ATTN: Document Control Desk
U. S. Nuclear Regulatory Commission
Washington, DC 20555-0001**SUBJECT:**Beaver Valley Power Station, Unit Nos. 1 and 2
BVPS-1 Docket No. 50-334, License No. DPR-66
BVPS-2 Docket No. 50-412, License No. NPF-73
Supplemental Response to Generic Letter 2004-02 (TAC Nos. MC4665 and MC4666)

Supplemental Response to Generic Letter 2004-02
for Beaver Valley Power Station Unit No. 1 and Unit No. 2
Page 1 of 208

BVPS-1 Safety Injection System Cold Leg Recirc Phase

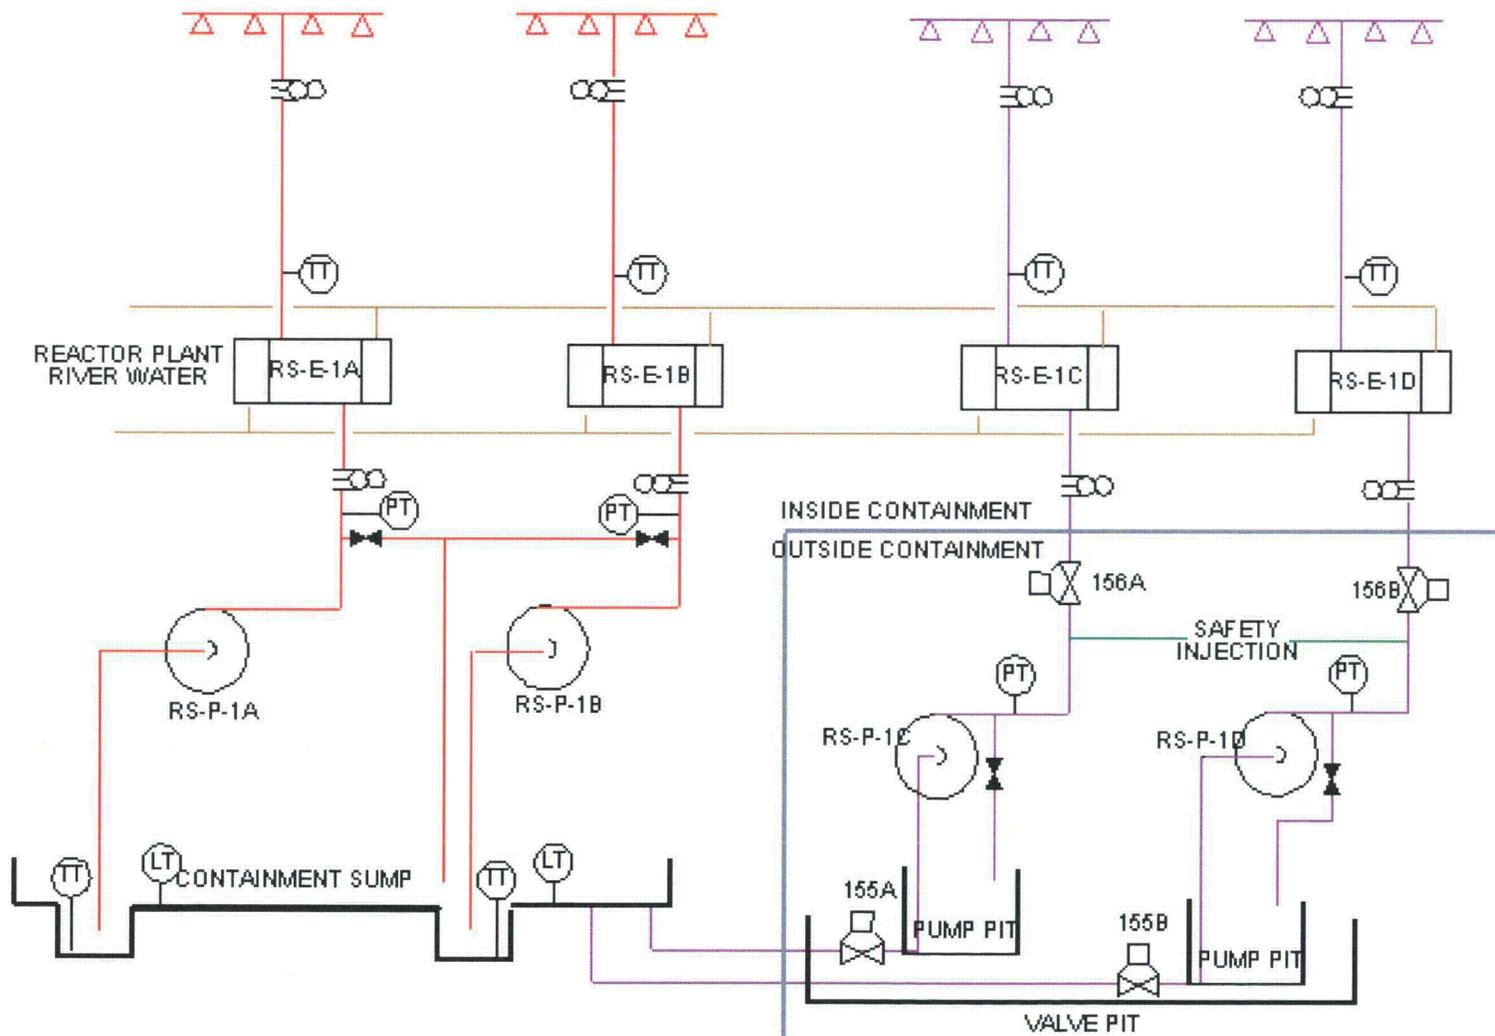
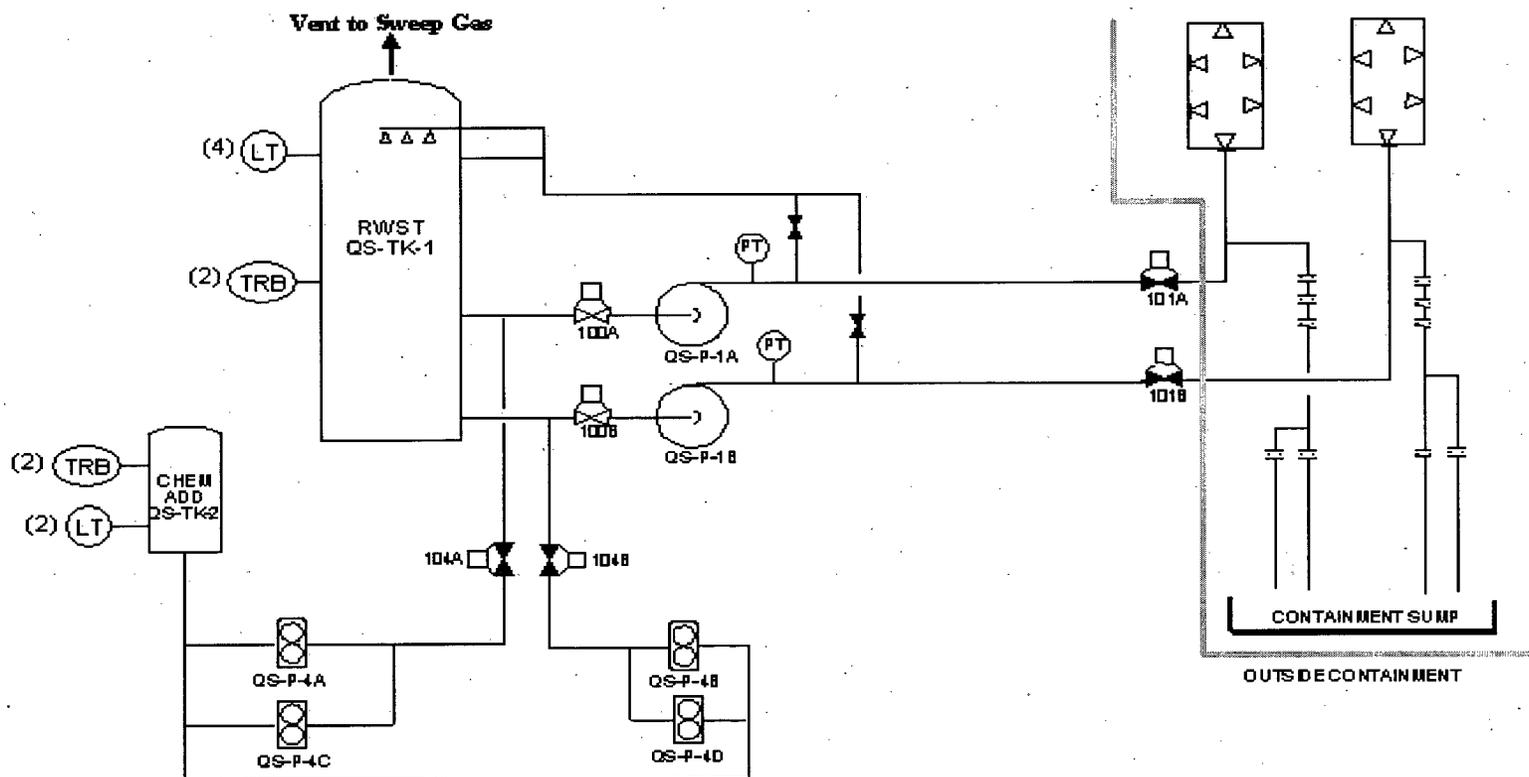
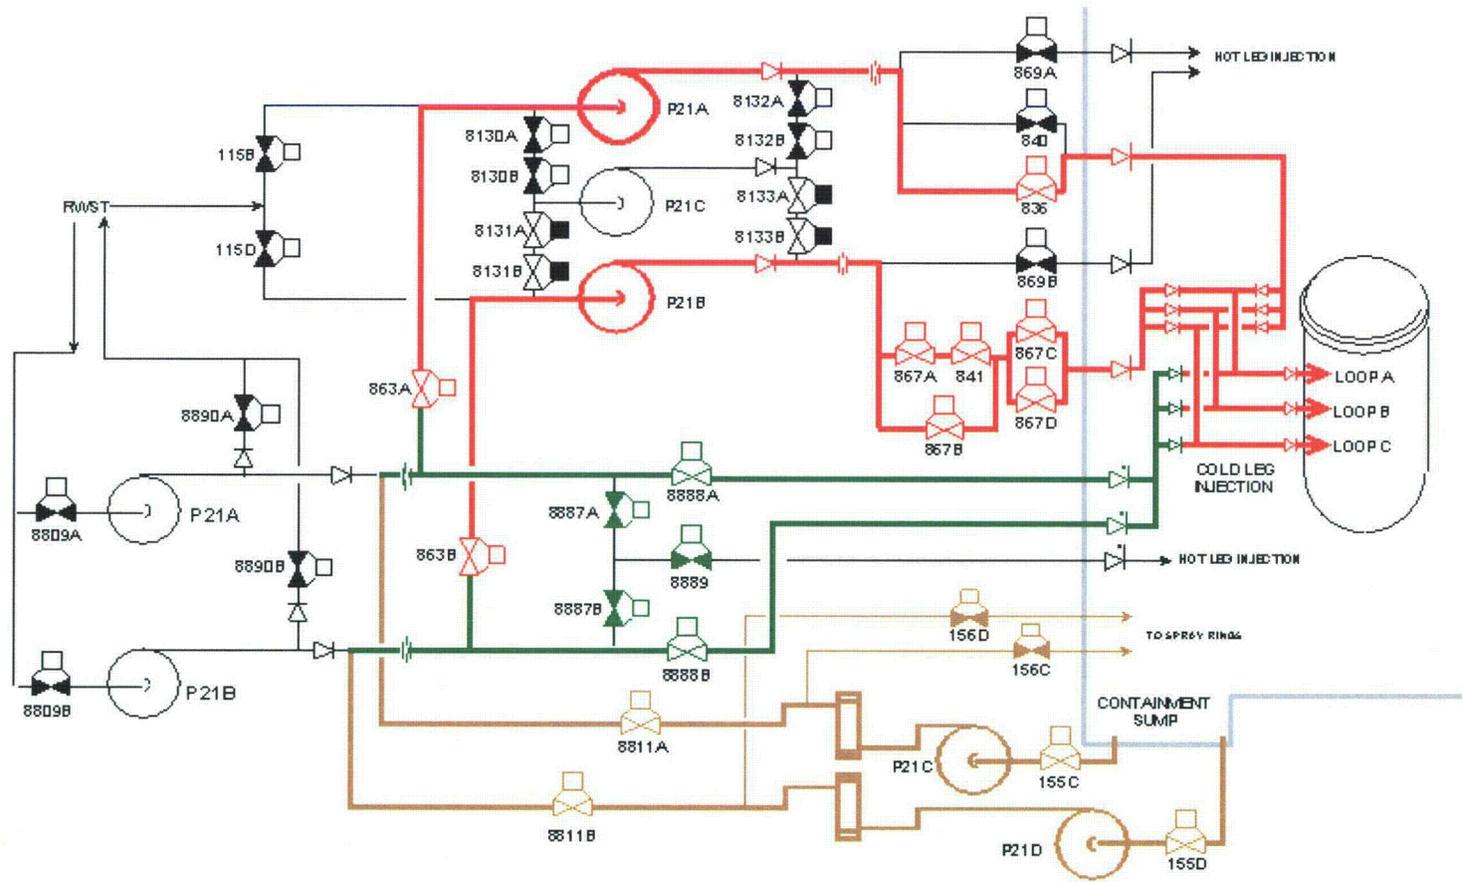
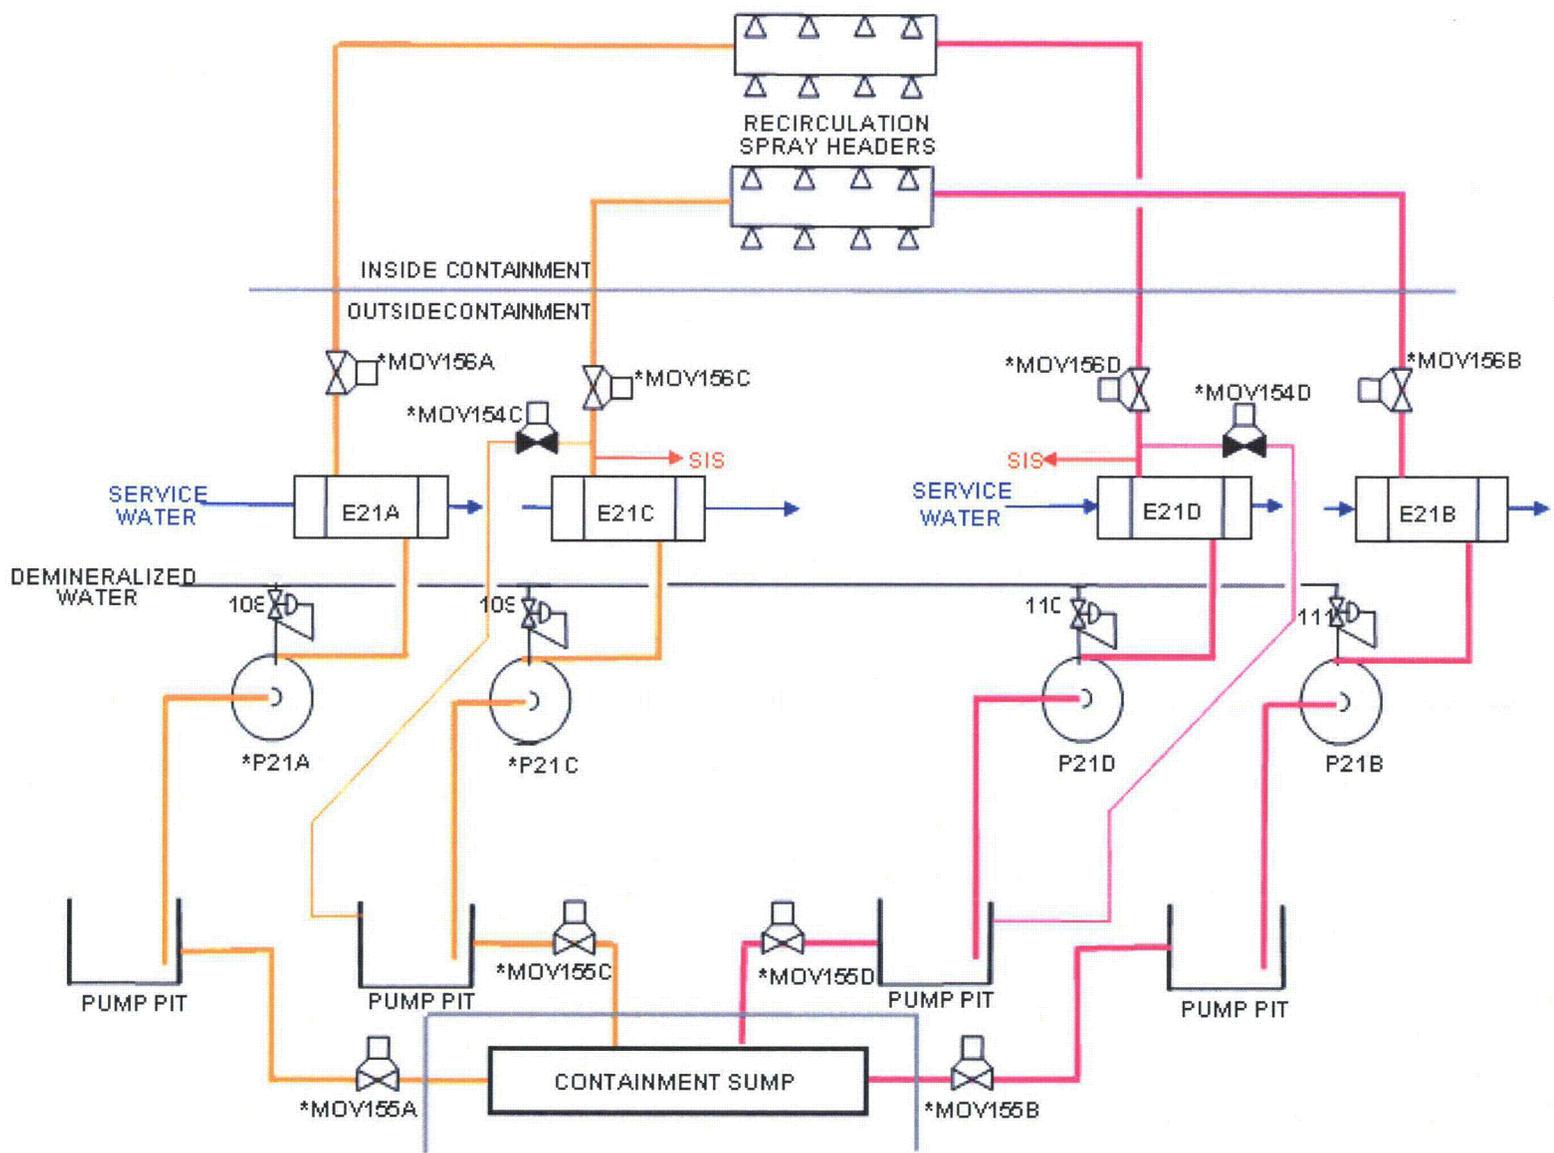
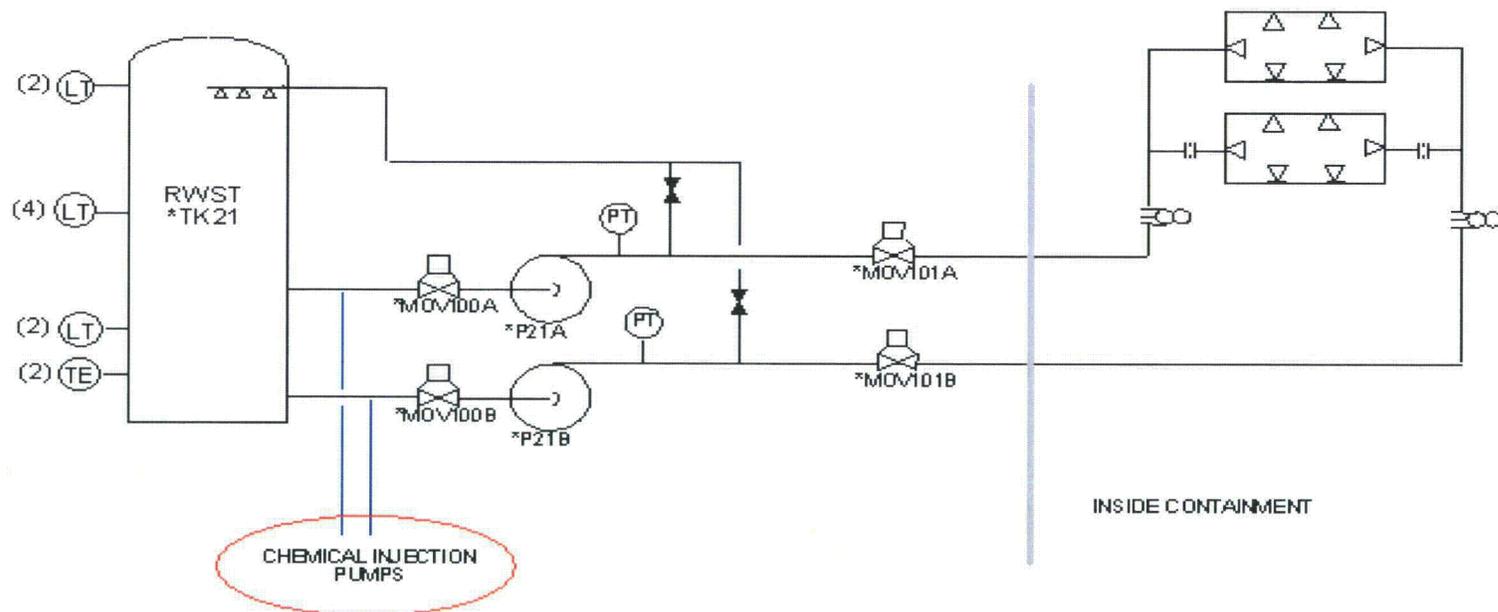
3.f.1 Provide a schematic diagram of the emergency core cooling system (ECCS) and containment spray systems (CSS).

Figure 3.g.16-1 BVPS-1 RSS pump Margin and Strainer Head Loss

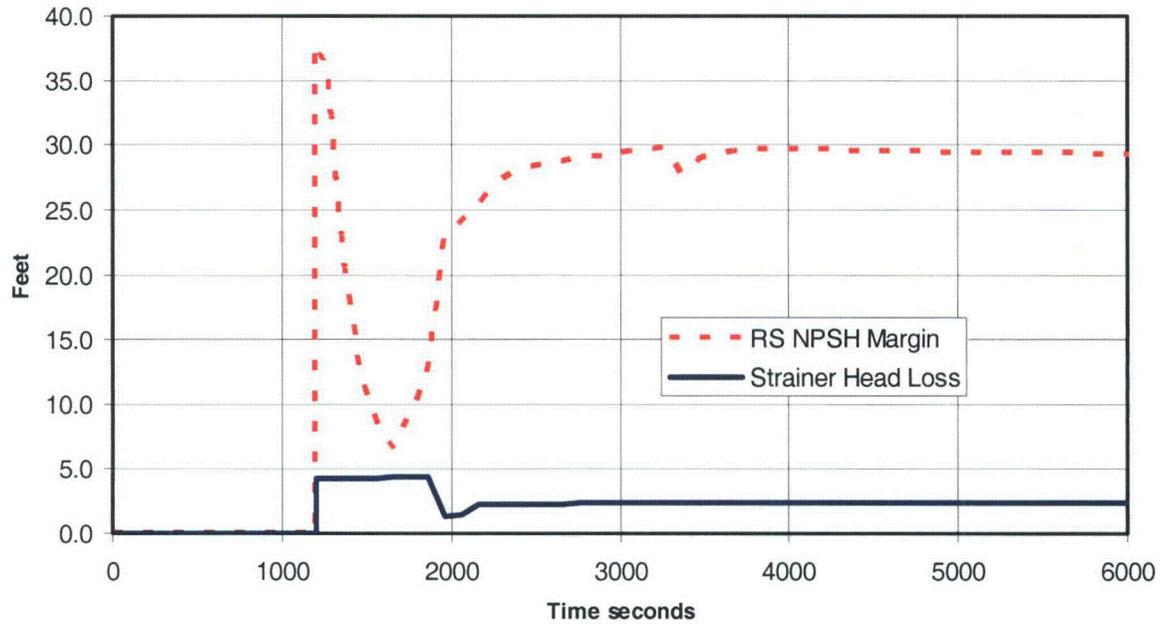
As can be seen from these tables, the limiting cases result in NPSH margins of 2.5 feet for the IRS pumps, 2.0 feet for the ORS pumps, and 3.4 feet for the LHSI pump. These margins are conservative since it is assumed that the full effect of chemical precipitates is present when the pumps initially take suction from the containment sump. As can be seen from the following figures, the minimum margin condition lasts only for a short period of time and margins increase as the containment sump level increases and the sump temperature decreases thereby increasing subcooling.

Figure 3.g.16-3 BVPS-2 RSS pump Margin and Strainer Head Loss

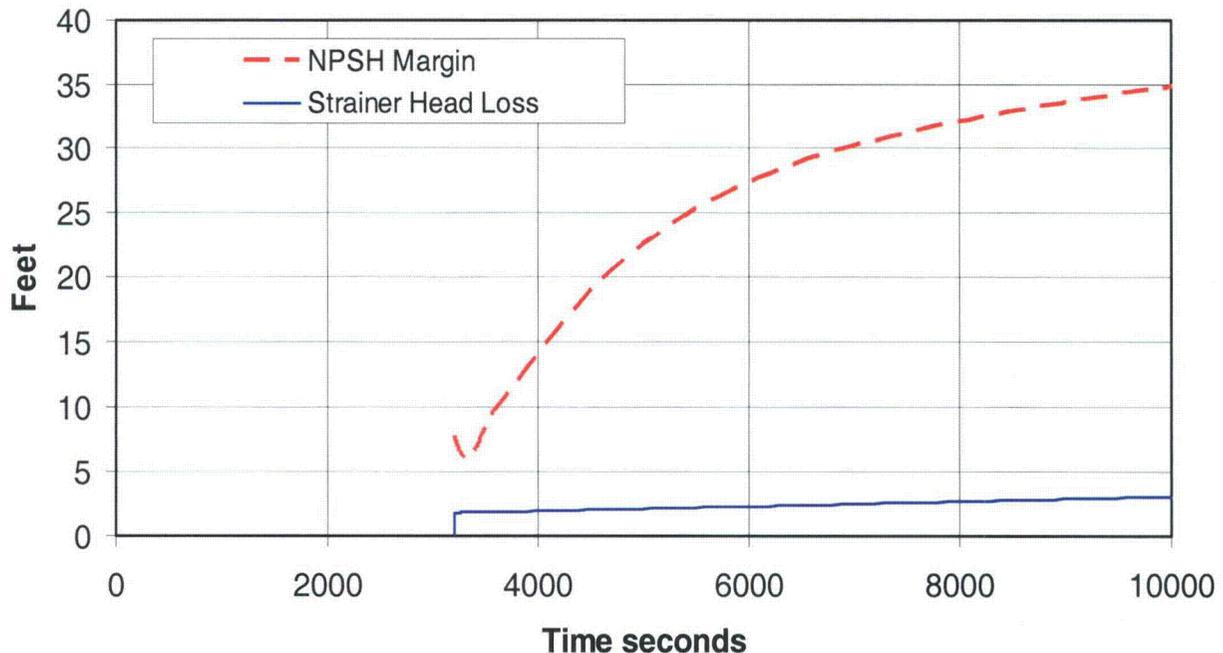
As shown in the table above, the minimum margin for the most limiting case is 4.3 feet for the BVPS-2 RSS pumps. Again this is a conservative value since the effects of chemical precipitates is applied at the onset of the accident. The trend of NPSH margin is shown in the following plot along with the strainer head loss for the limiting margin case.
